**Town of Duanesburg
Zoning Board of Appeals
August 16th, 2022**

PROPOSED SITE PLAN FOR
OAK HILL SOLAR 1&2
APPLICANT:
OAK HILL SOLAR 1, LLC & OAK HILL SOLAR 2, LLC
13950 DUANESBURG ROAD
TOWN OF DUANESBURG, SCHENECTADY COUNTY, NEW YORK

Exhibit B Biggs/Bruning to Zoning Board June 20, 2022

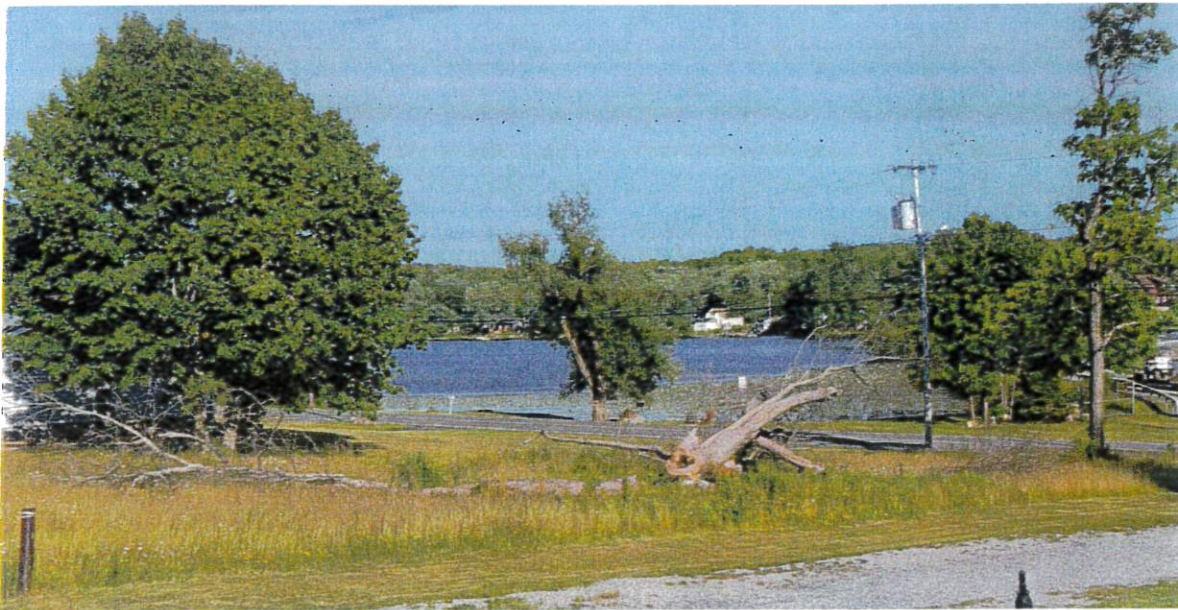
Position of the house to the West of 2610. Note the angle of the house which was done for the views of the lake.

Submitted March 11, 2019
Resubmitted June 6, 2019

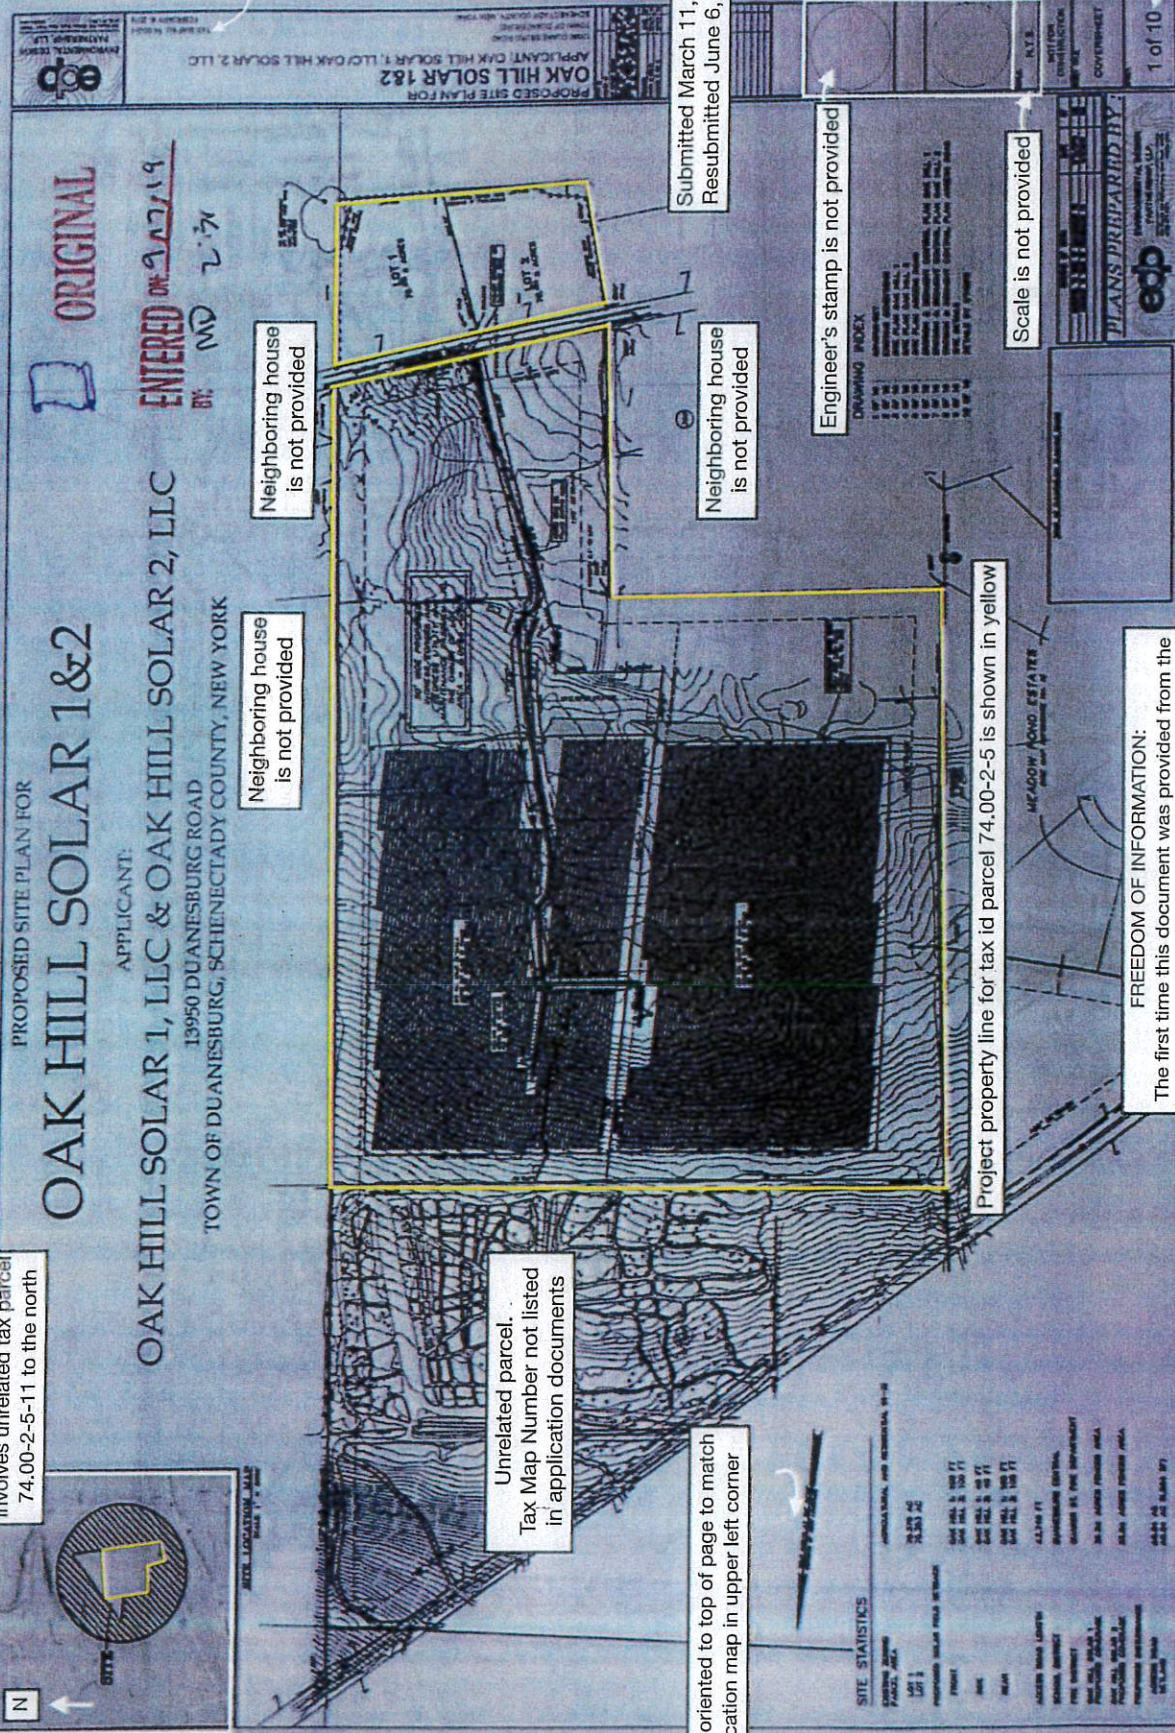
Neighboring house is not provided

Engineer's stamp is not provided

Project property line for tax id parcel 74,00-2-5 is shown in yellow

DRAWING INDEX

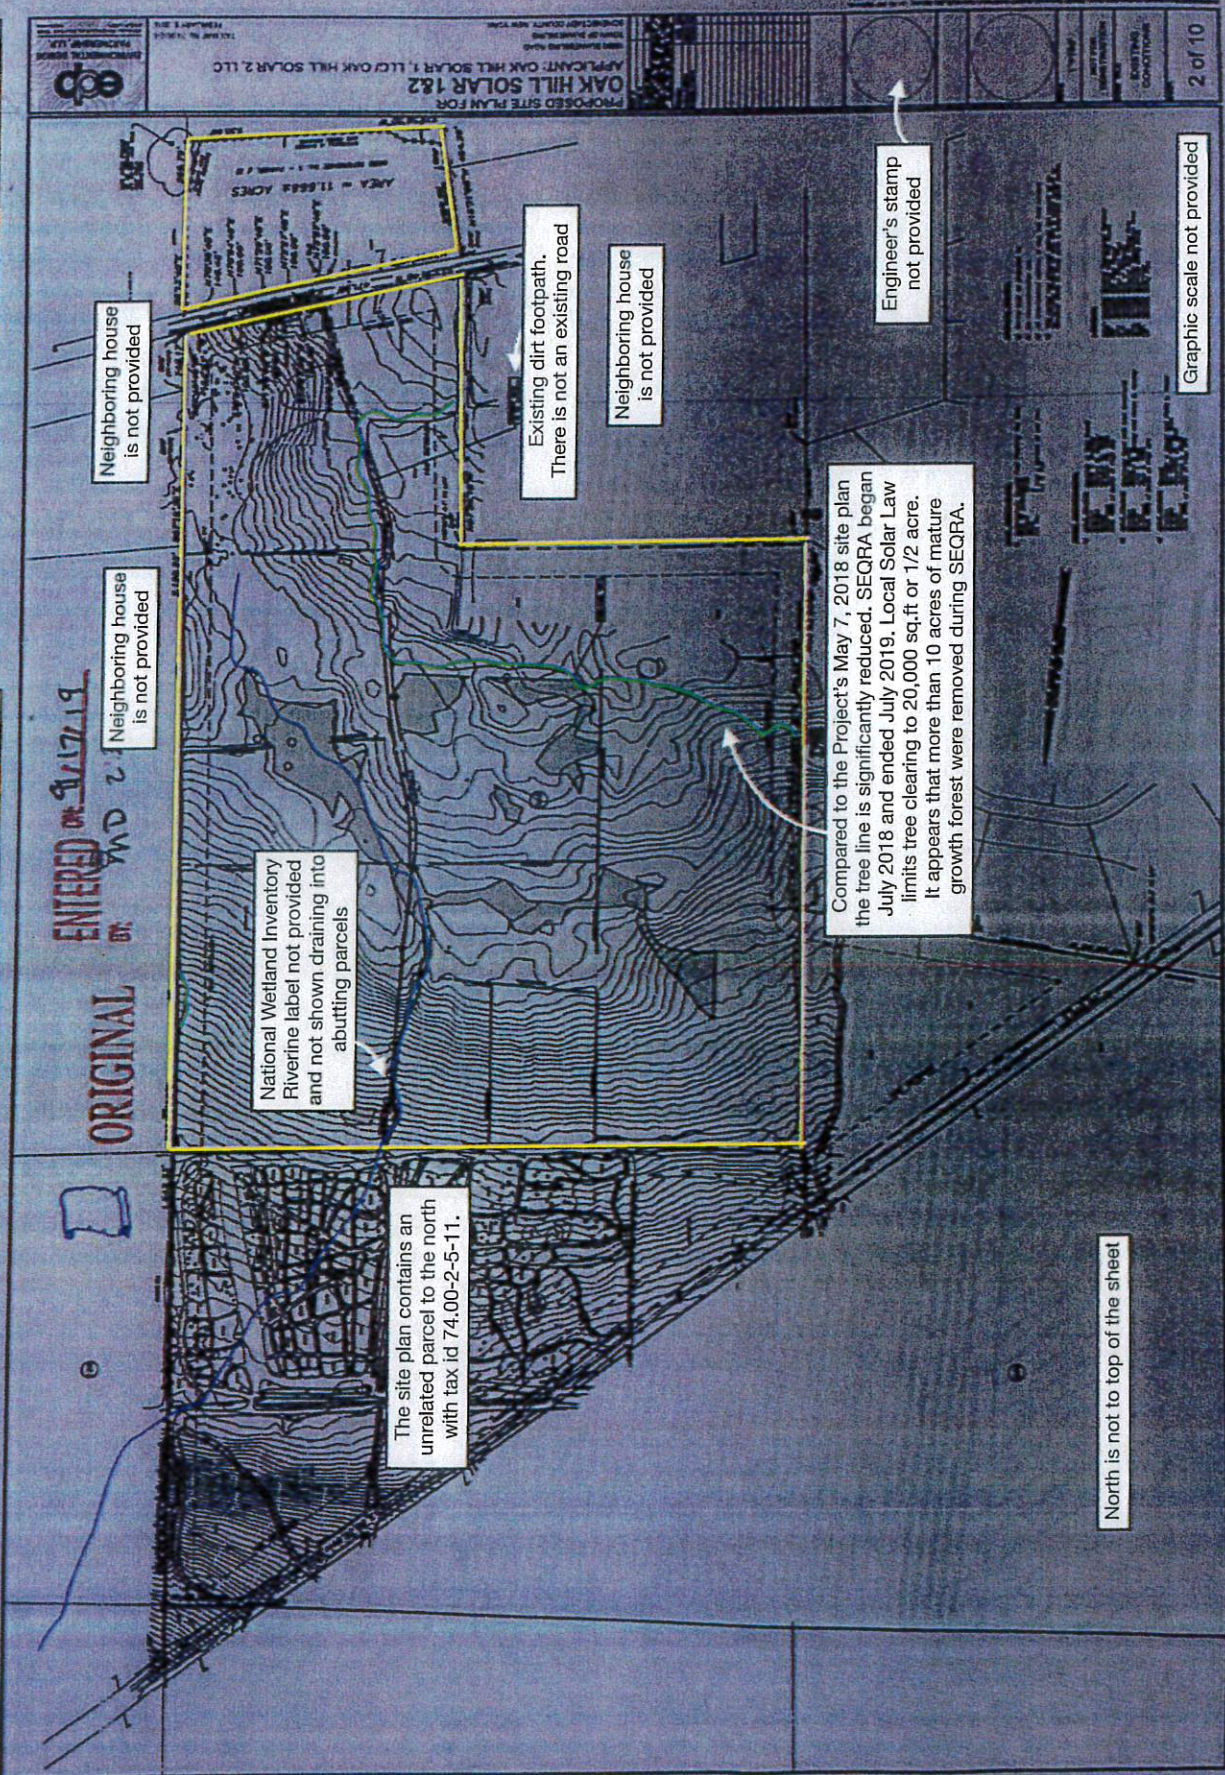
Site Plan omits September 5, 2019 Sheet 11, Landscaping Plan.

Image is not centered on the page

PROPOSED SITE PLAN FOR
 OAK HILL SOLAR 1&2
 APPLICANT: OAK HILL SOLAR 1, LLC / OAK HILL SOLAR 2, LLC
 3 of 10

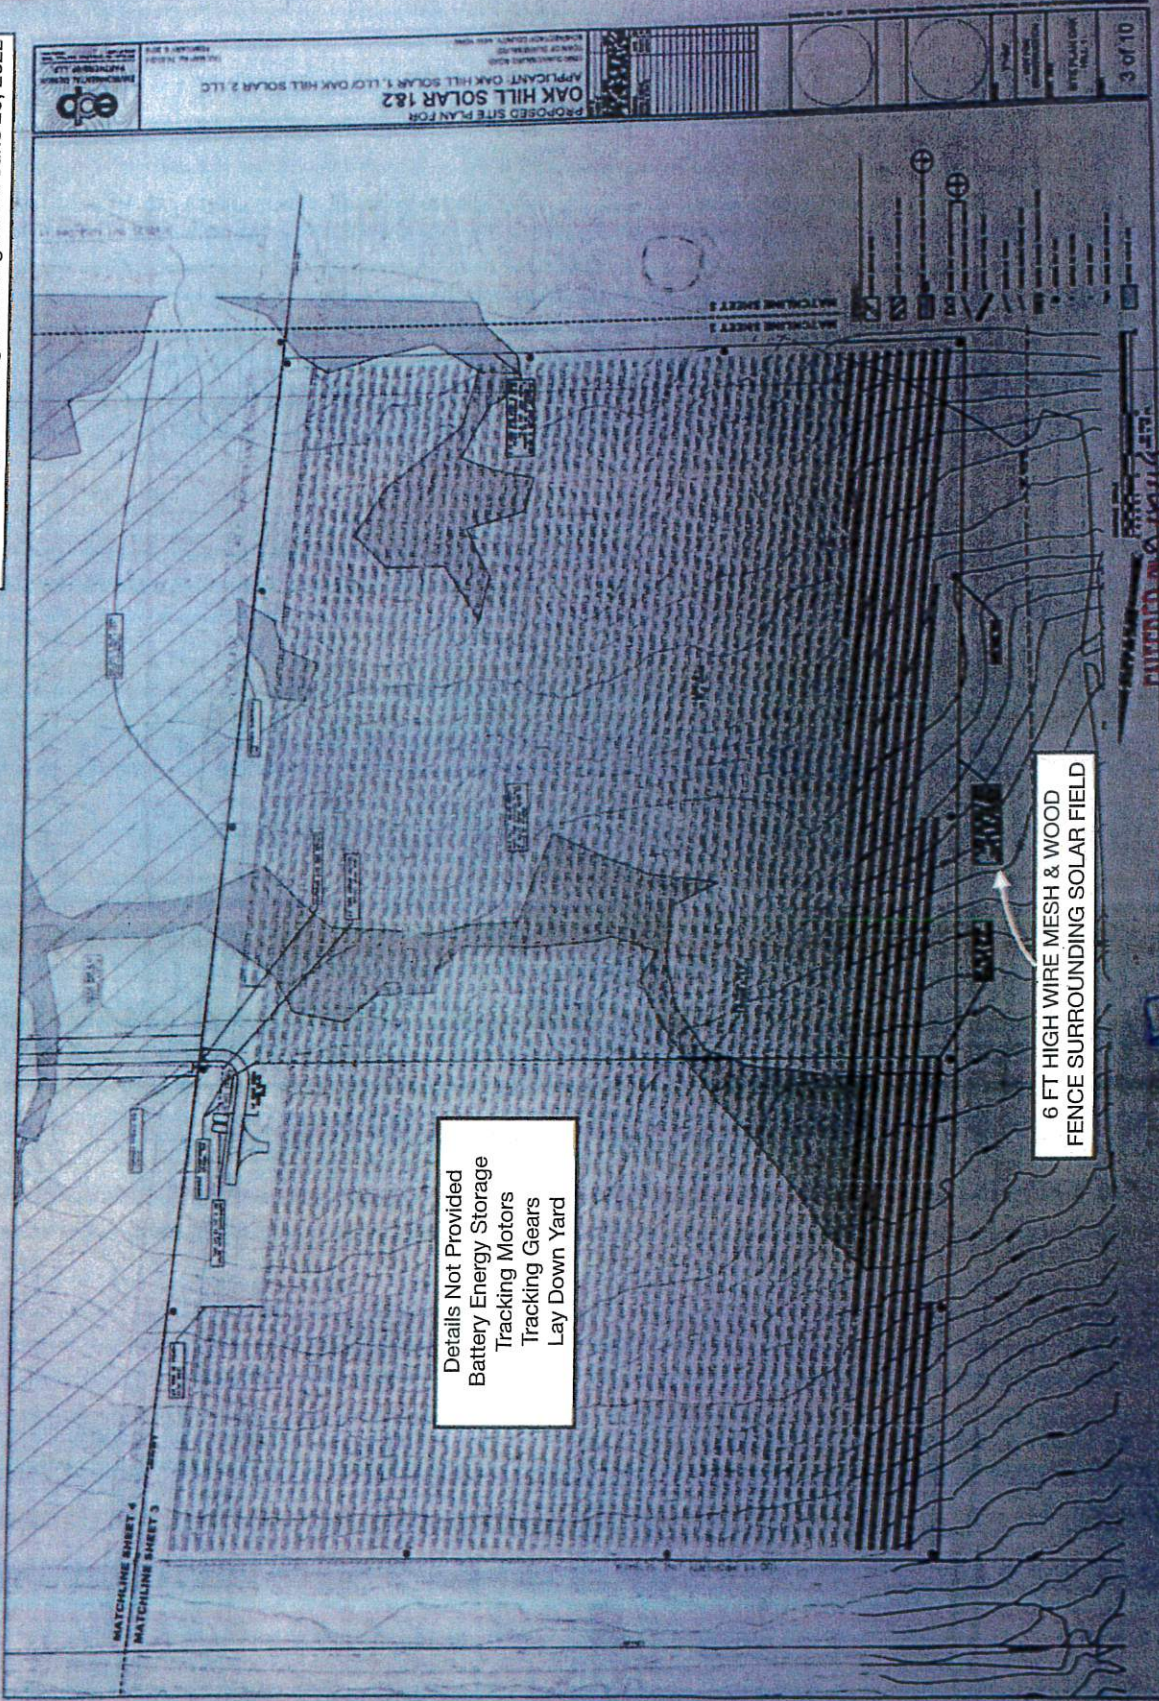
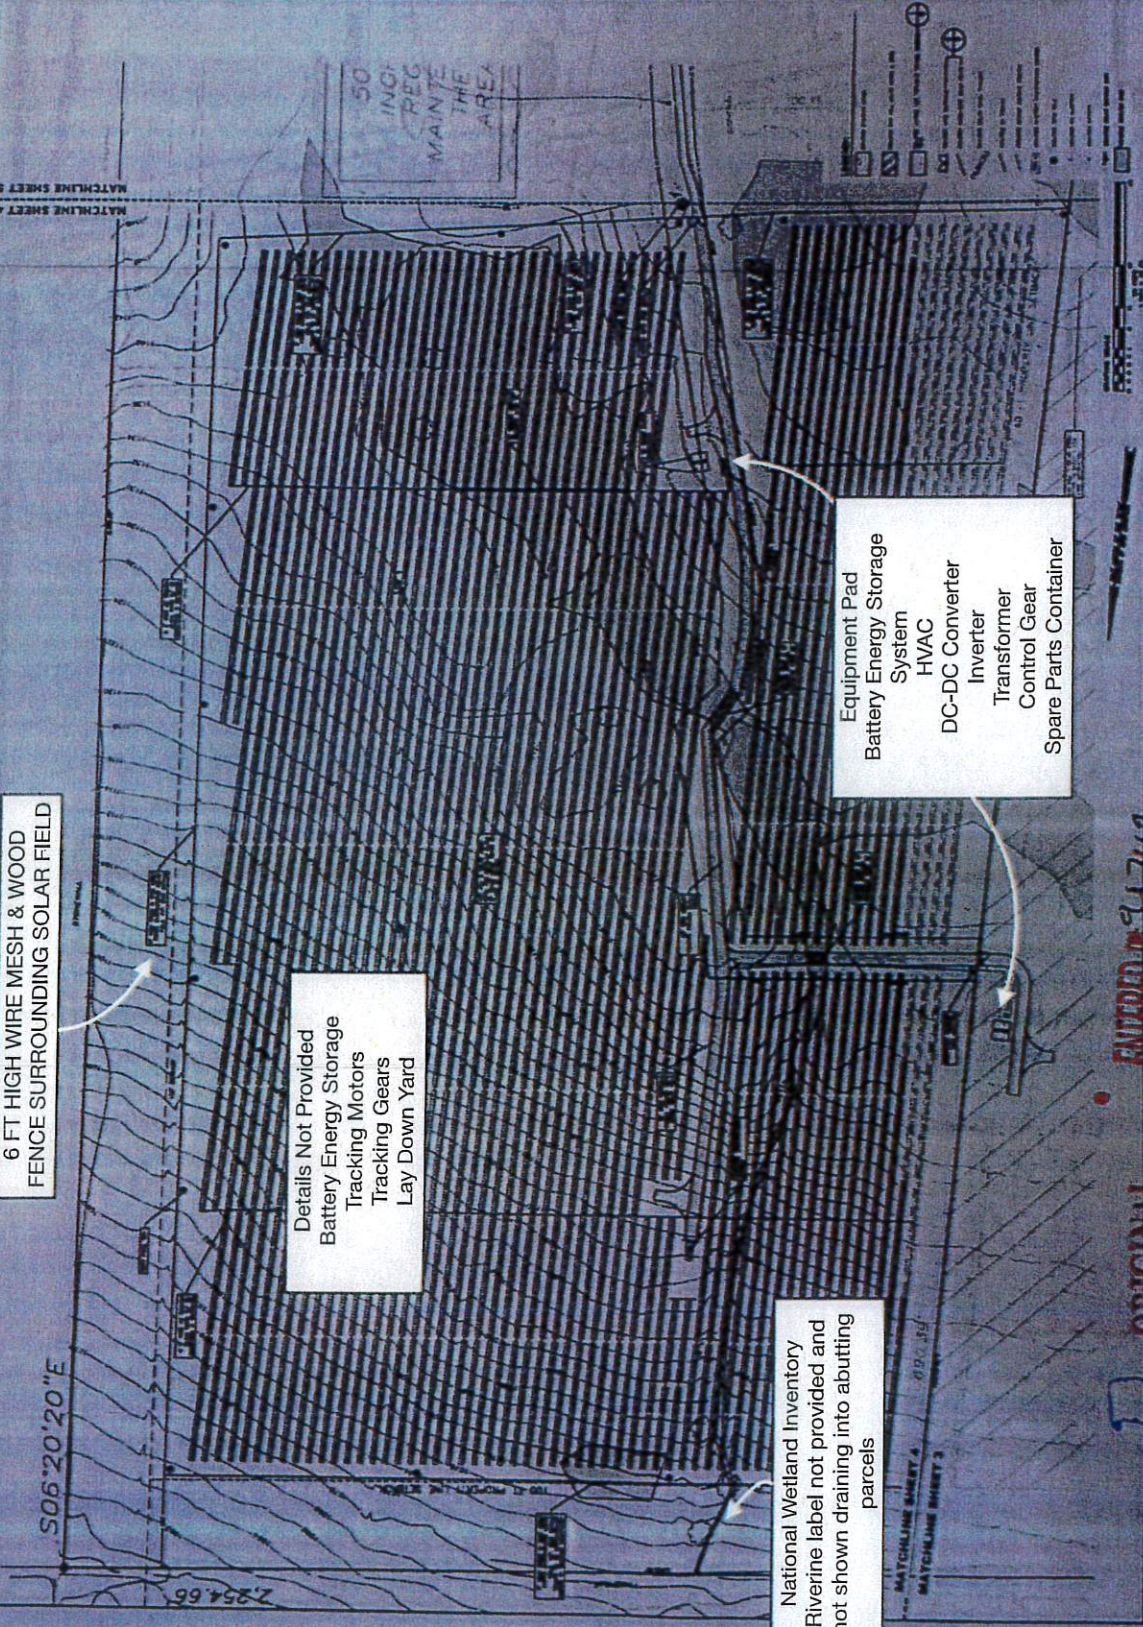
Details Not Provided
 Battery Energy Storage
 Tracking Motors
 Tracking Gears
 Lay Down Yard

6 FT HIGH WIRE MESH & WOOD
 FENCE SURROUNDING SOLAR FIELD
